Berkshire Regional Planning Commission Clearinghouse Review Report

SUBJECT: Big Y Supermarket
EEA#: 14577
LOCATION: LEE
ESTIMATED COST: \$9 million
REVIEW TYPE: Expanded ENF
PROPONENT: Big Y Foods, Inc. c/o SK Design Group, Inc.
COMMENTS DUE: May 21, 2010

Non-motorized access and amenities

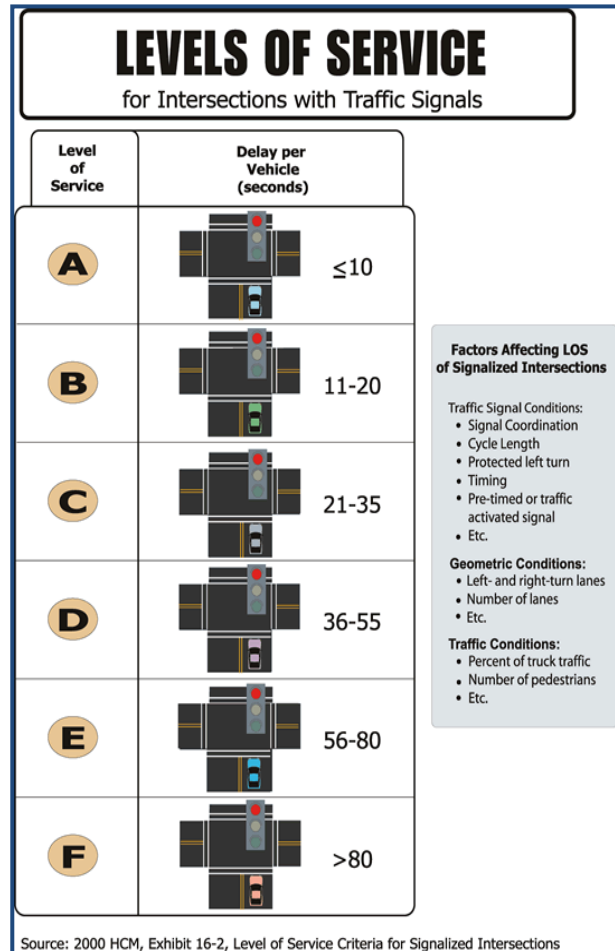
The proponent should clearly define internal pedestrian access and locations for bicycle lockers and racks.
